**RE: RESPONSE TO THE REQUEST FOR ADDITIONAL INFORMATION
30 GEORGE STREET, MANLY
DA2024/0179**

This cover letter is in response to a request for additional information dated 23 April 2024 in relation to DA2024/0179.

Figure 2: Realestate.om.au floor plan of neighbouring site at No. 28 George Street, Manly.

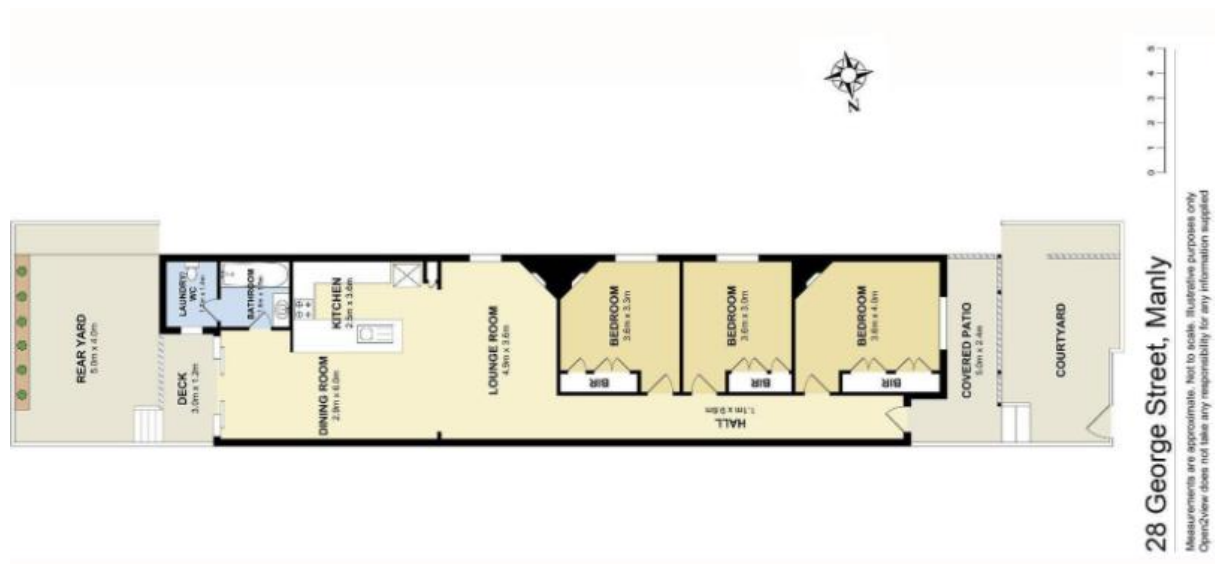
The revised shadow diagrams continue to illustrate that new shadows resulting from the proposed development are predominately cast onto the roof form of No. 28 George Street, which contains skylights. A review of floorplans available on realestate.com.au, and demonstrated in Figure 2, reveals that two skylights service the open-plan kitchen/dining area and primary living area.

The shadow diagrams prepared for the winter solstice demonstrate that this skylight retains solar access from 11am to 3pm for a total of 4 hours, achieving compliance with this control.

Figure 6: Aerial imagery of site line to a listed Heritage Item.

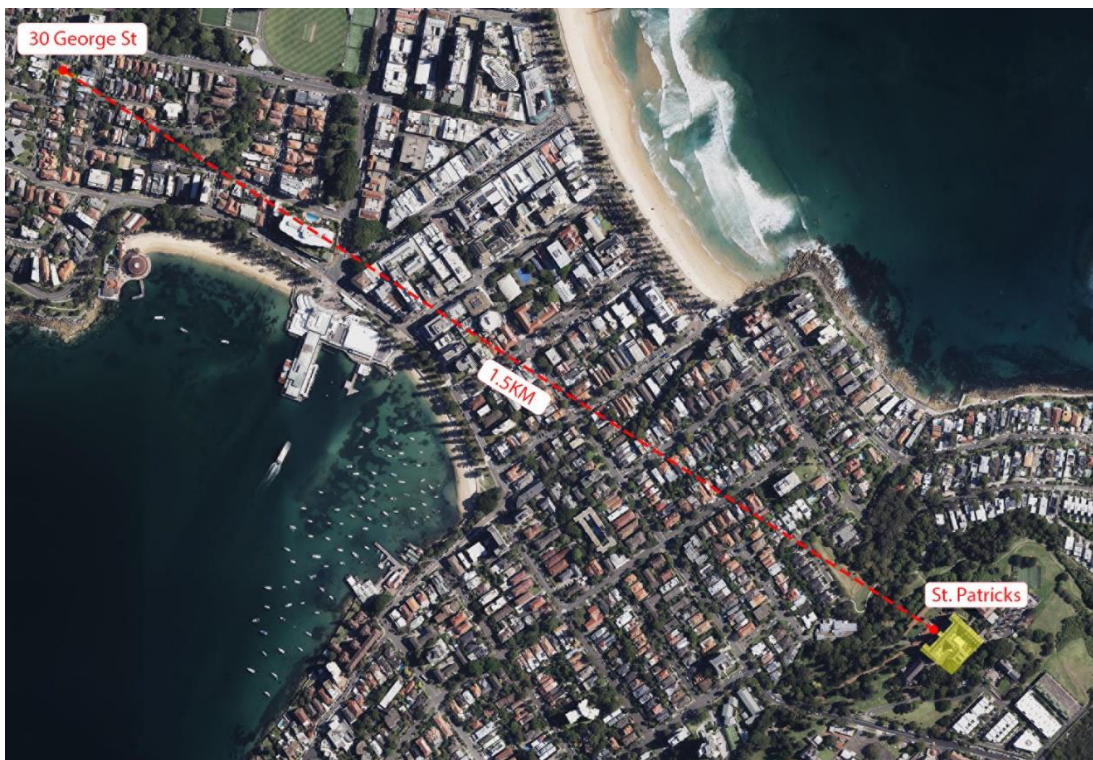
It should be noted that the view obtained from No. 32 George Street is over numerous properties (including side boundaries) and is of a building set a 1.5km distance from the window, as identified in Figure 6 below:

Due to the distance of the site from the views obtained, there is no guarantee that the view will be retained in the future due to future development potential within the 1.5km separation and potential unmitigated growth of vegetation. Due to this uncertainty, it would be unrealistic to retain a view that is obtained over a great distance and multiple properties.
